PRELIMINARY SITE GRADING CONSTRUCTION PLANS
FOR
CREEKSIDE AT LORSON RANCH FILING NO. 1
EARLY GRADING / EROSION CONTROL PLANS

PROJECT:
CREEKSIDE AT LORSON RANCH FILING NO. 1
LORSON BLVD AND COTTONWOOD GROVE DR.
COLORADO SPRINGS, COLORADO

**COVER SHEET
EARLY GRADING AND
EROSION CONTROL PLAN**

DATE: DECEMBER 5, 2018
 PROJECT NO. 100.045
 SHEET NUMBER **C4.2**
 TOTAL SHEETS: 17

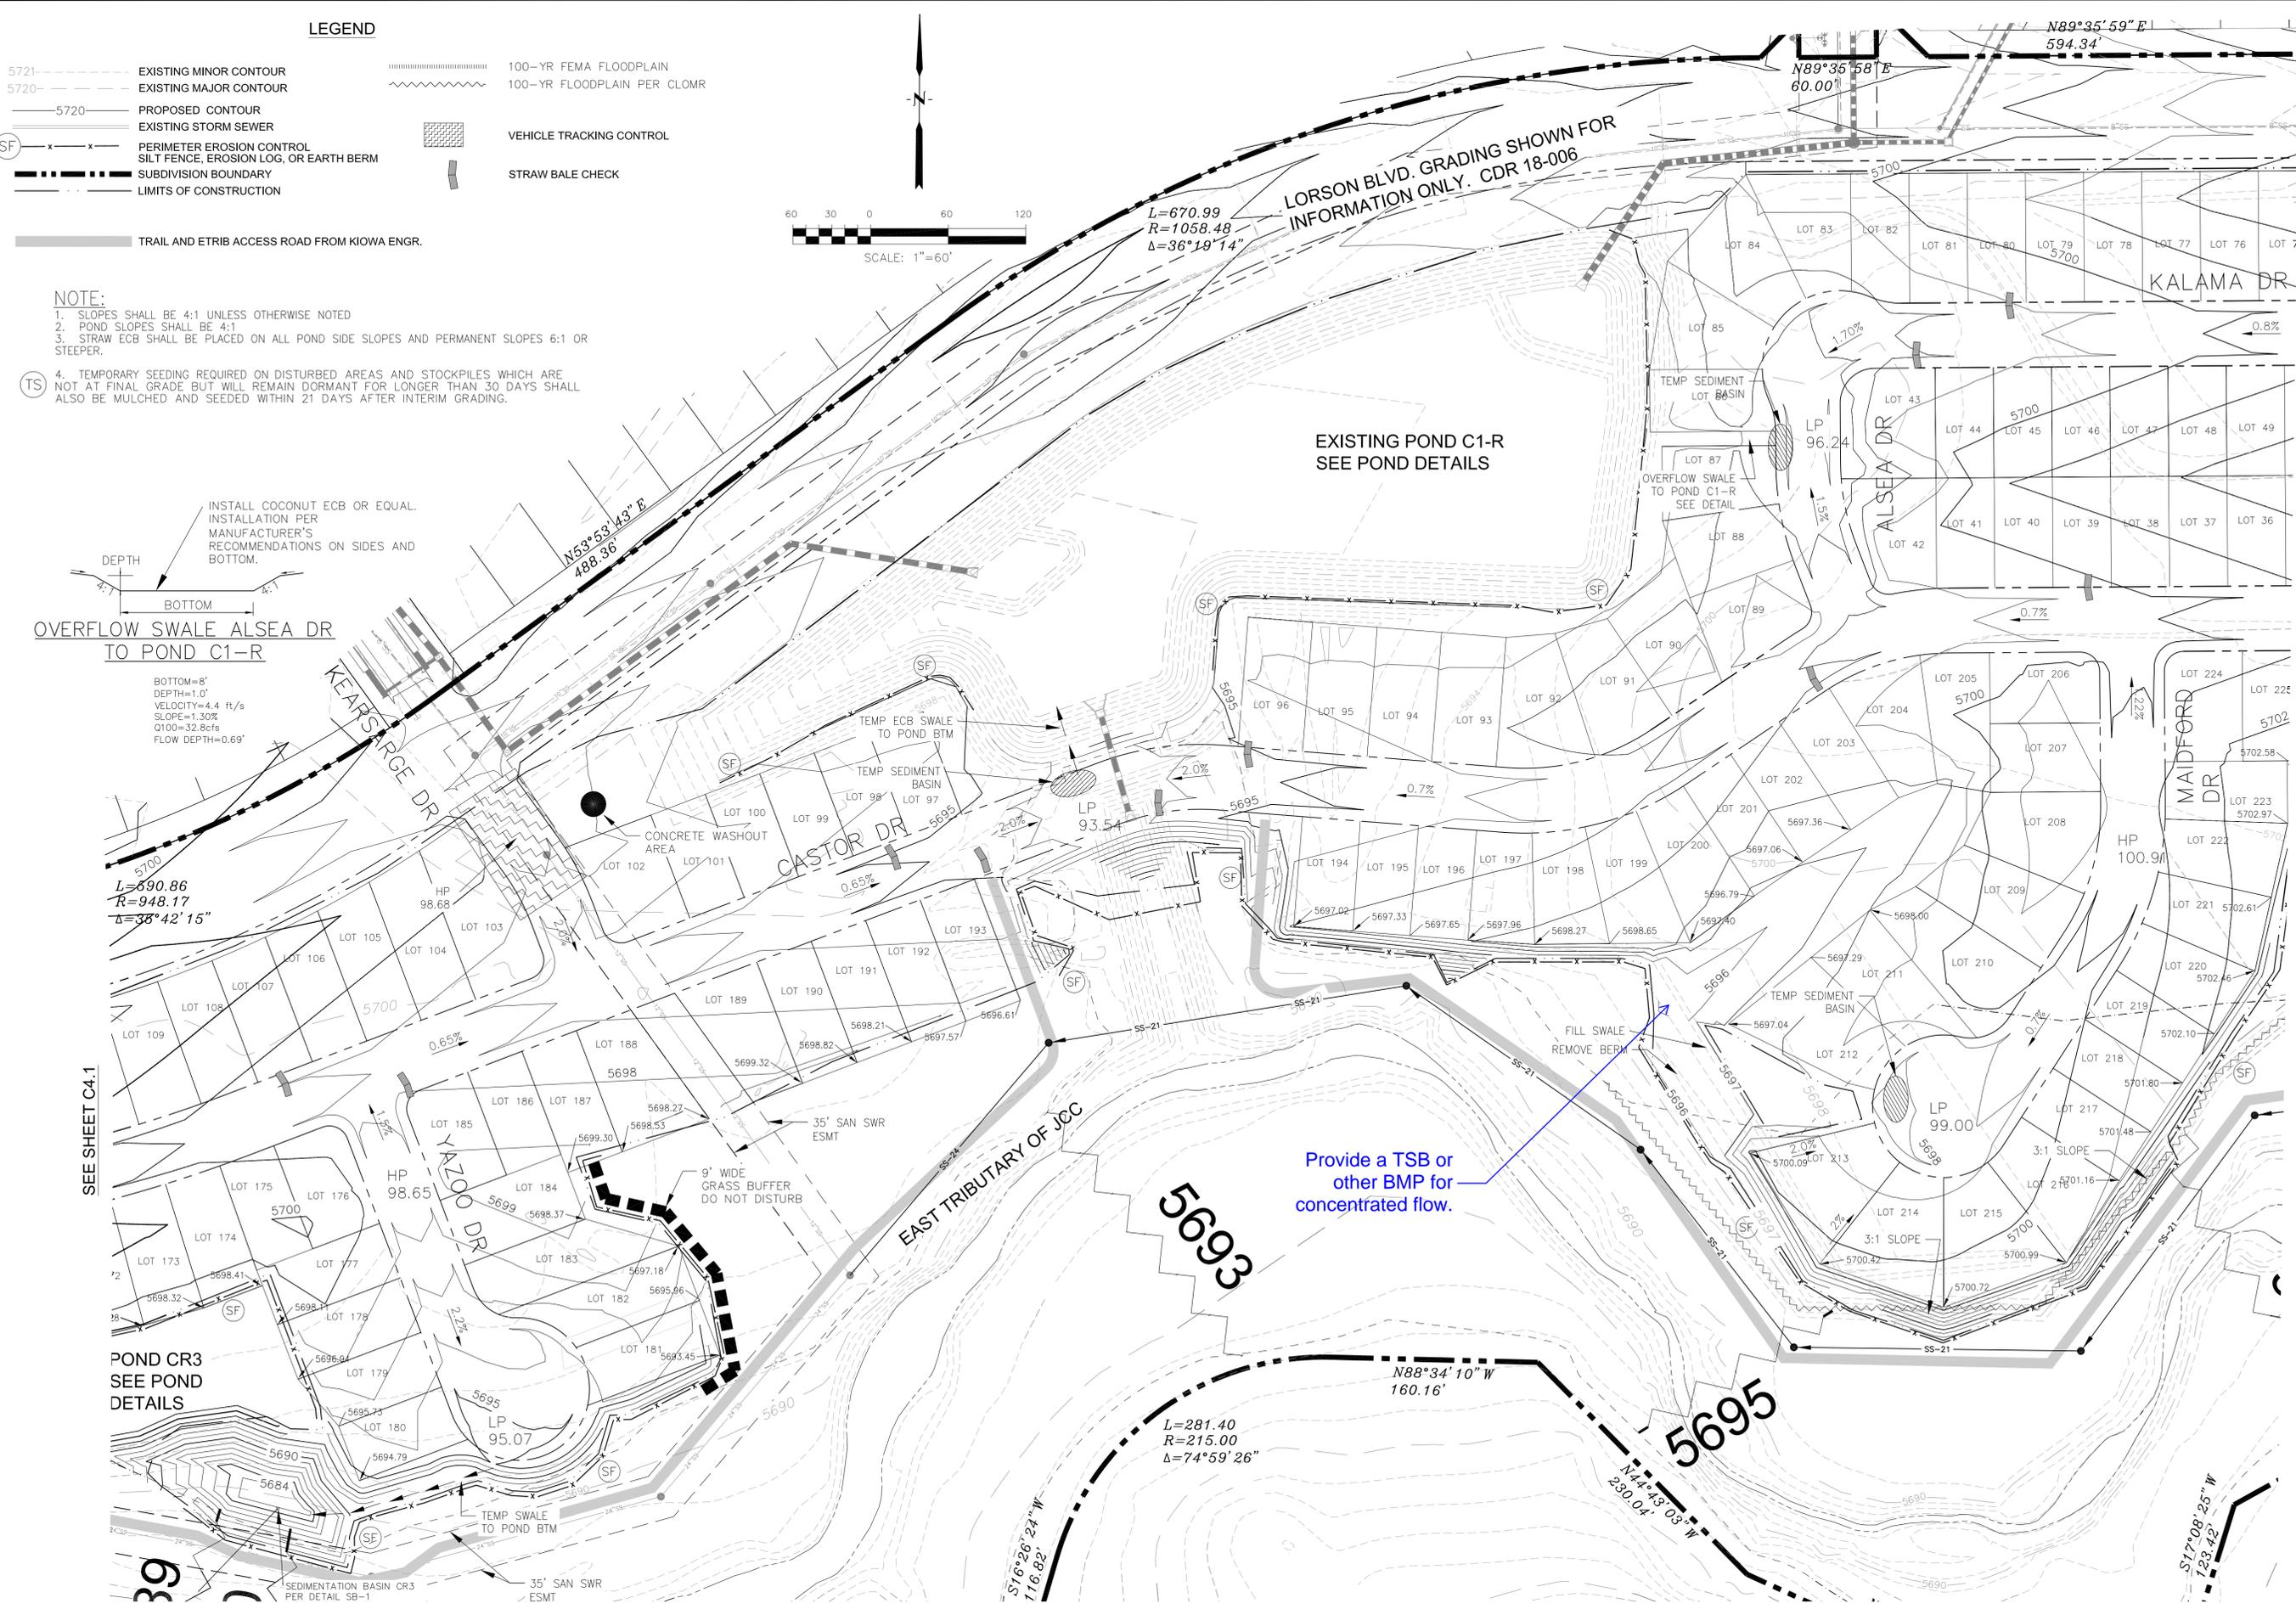
Provide a TSB or
other BMP for
concentrated flow.
